DECISION OF THE PLANNING ADMINISTRATOR

CLASS 3 SITE PLAN REVIEW CASE NO.: SPR25-08

IN THE MATTER OF APPROVAL OF)	FINDINGS & ORDER
CLASS 3 SITE PLAN REVIEW)	
CASE NO. SPR25-08)	
1317 STATE ST)	April 21, 2025

Summary: A building addition and parking lot reconfiguration for an existing *retail sales* use.

① SITE UTILITY & STORMWATER PLAN
3/32" = 1'-0"

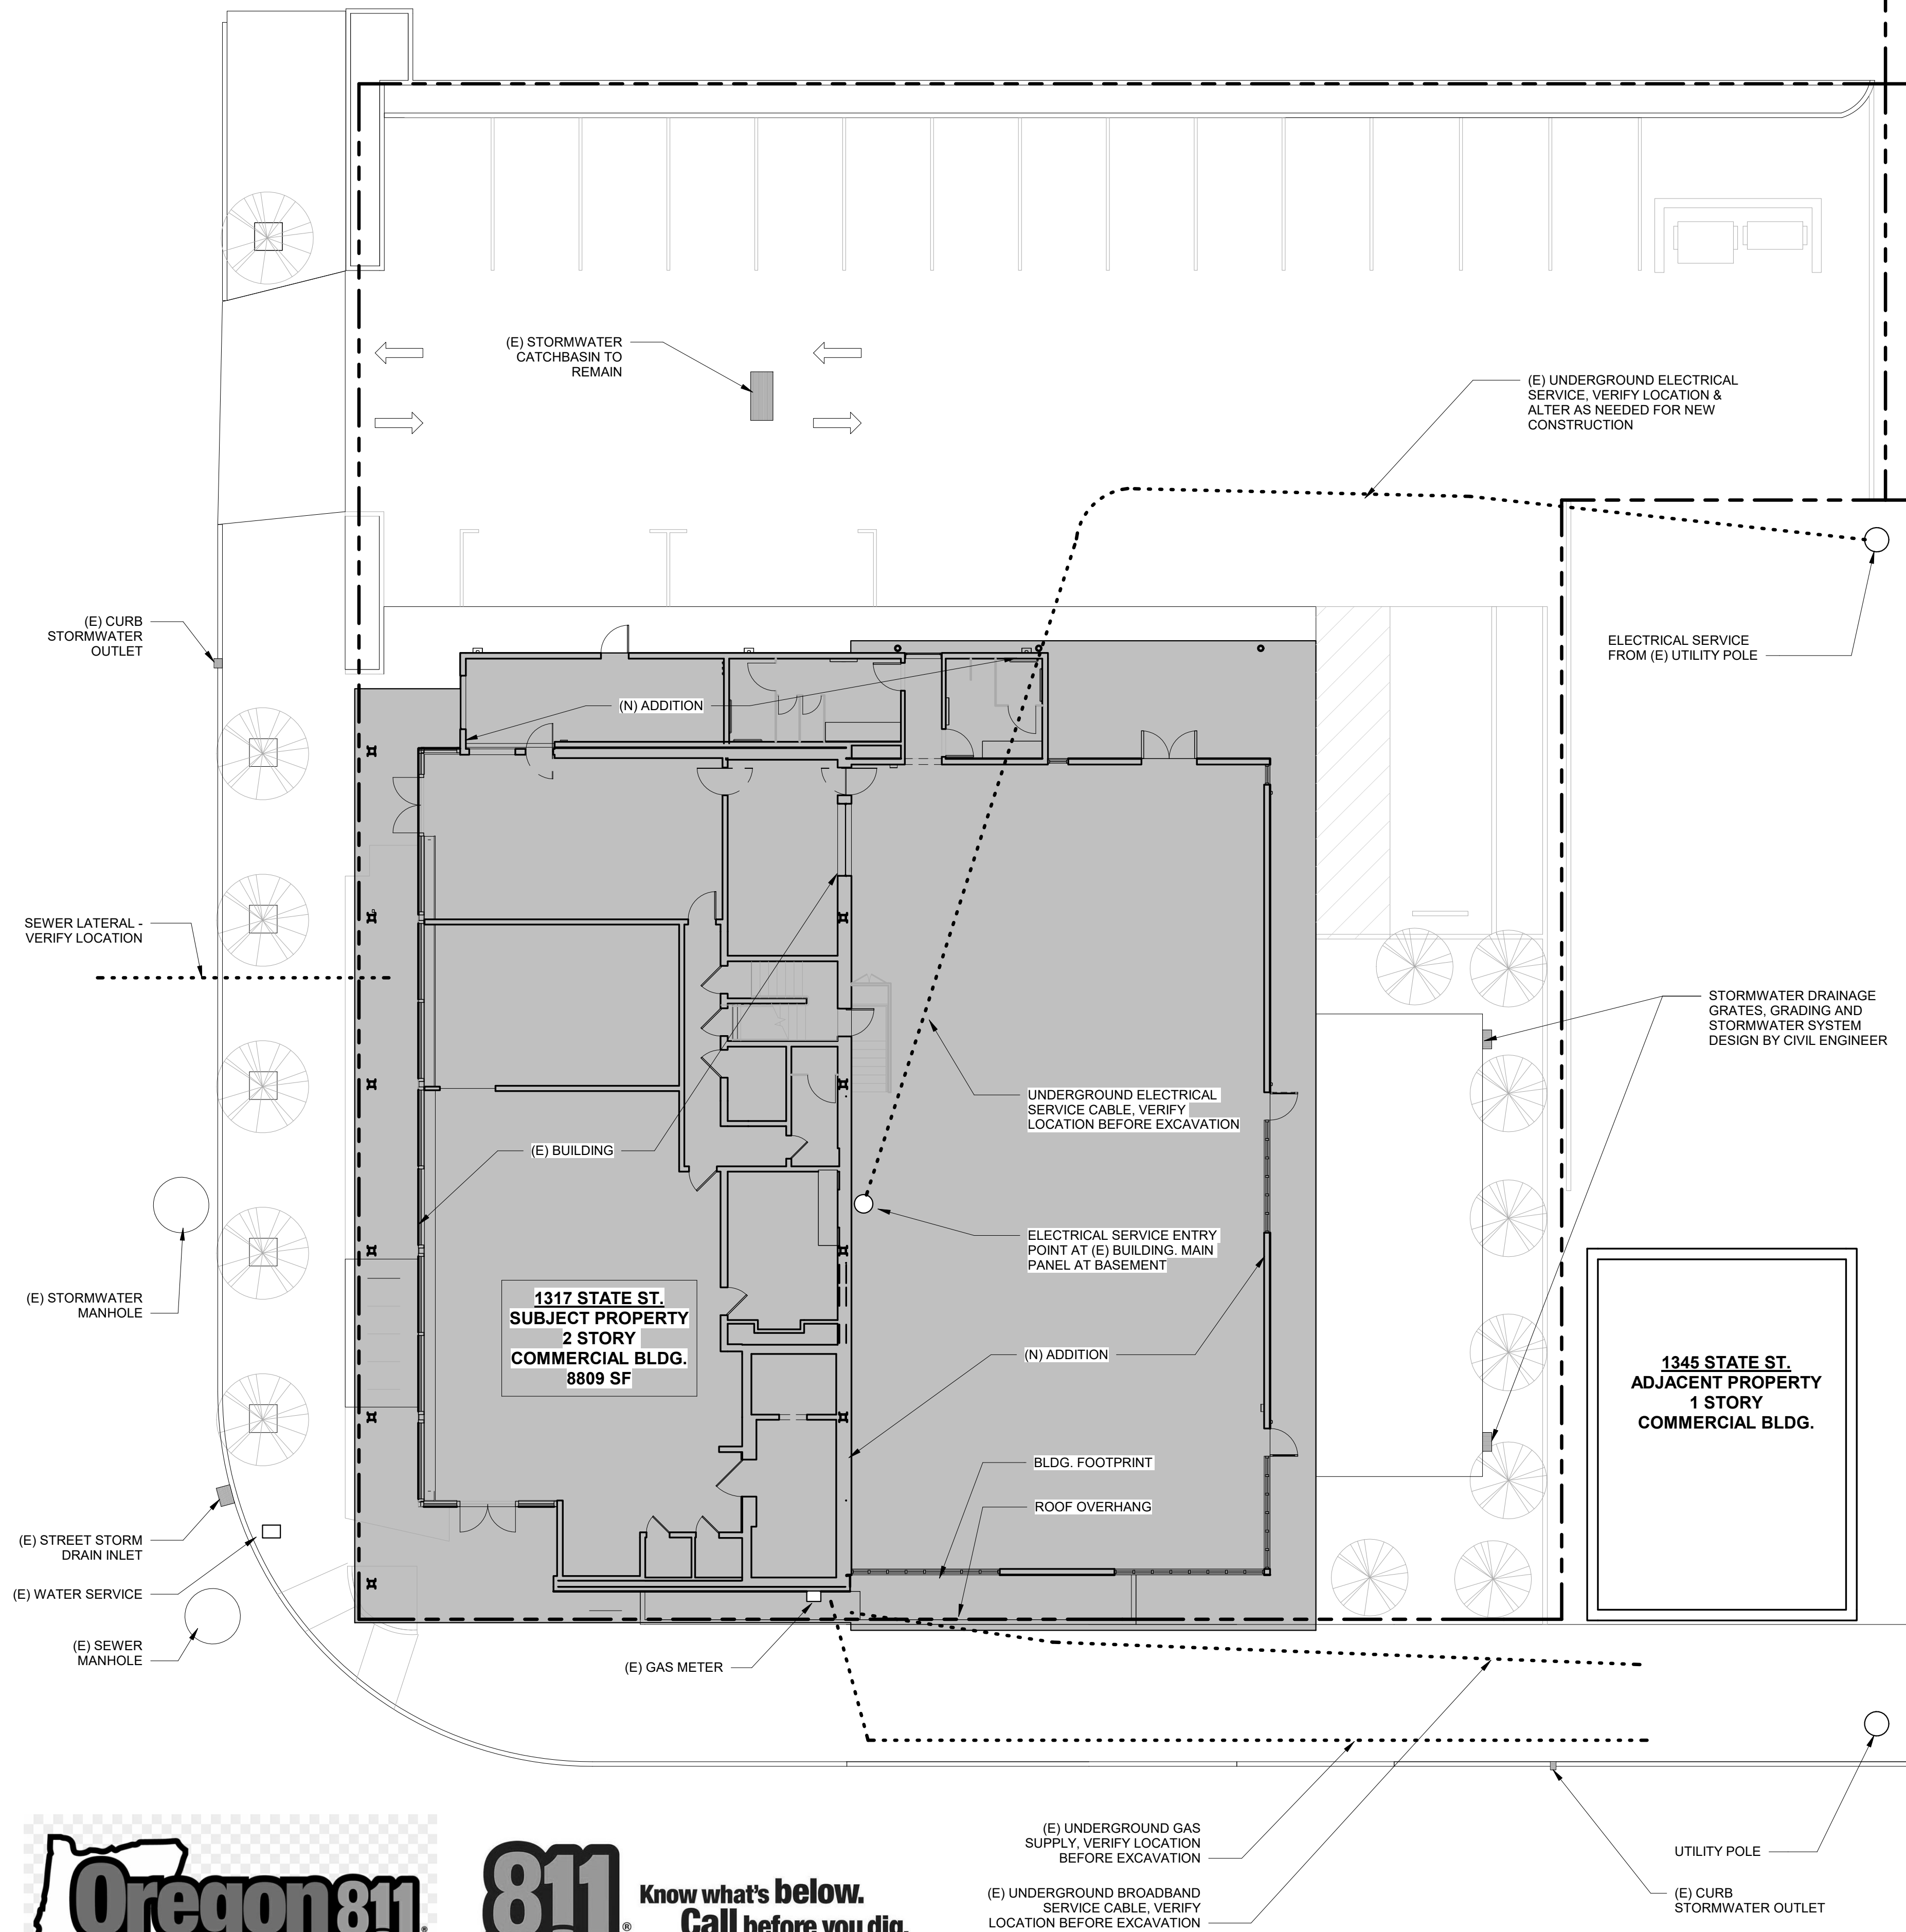
Finding: Public water, sanitary sewer, and stormwater infrastructure is available along the perimeter of the site and appears to be adequate to serve the property as shown on the applicant's preliminary utility plan. The applicant shall design and construct all utilities (sewer, water, and storm drainage) according to the PWDS and to the satisfaction of the Public Works Director. The applicant is advised that a sewer monitoring manhole may be required, and the trash area shall be designed in compliance with Public Works Standards.
